New York State Department of Environmental Conservation

August 11, 2011

Re: Hudson River Valley Resort Project
DEC Application #: 3-5146-00063/00007
Town of Rosendale, Ulster County
DEIS COMMENTS

BLASTING CHART - GROUND VIBRATION LIMITS

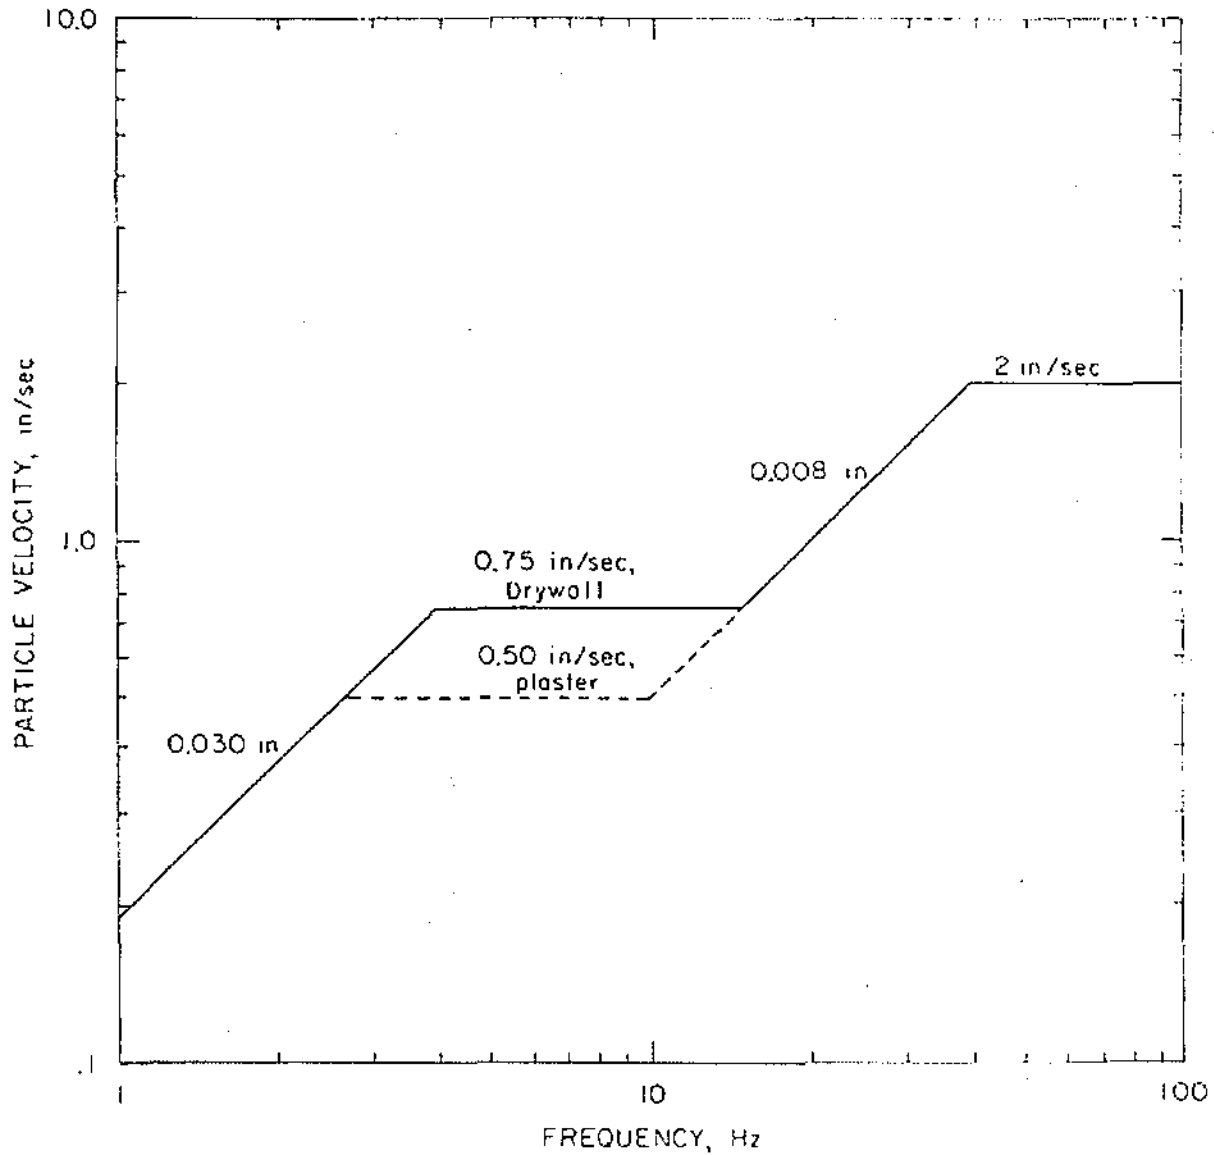
- c. For each phase, calculate the change in dB to the nearest receptors from ambient.
36. When discussing blasting impacts, the corresponding frequency (in hertz) must be considered in addition to the Peak Particle Velocity (PPV). The PPV is proposed to be limited to 0.5-4.0 in "Wildlife Sensitive Areas", but frequency must also be established and limited. Refer to the attached blasting chart, compliance with which is now a requirement of all DEC Mined Land Reclamation Permits. Please also refer to item 3 regarding the lack of information on the vertical and lateral extent of the mines.
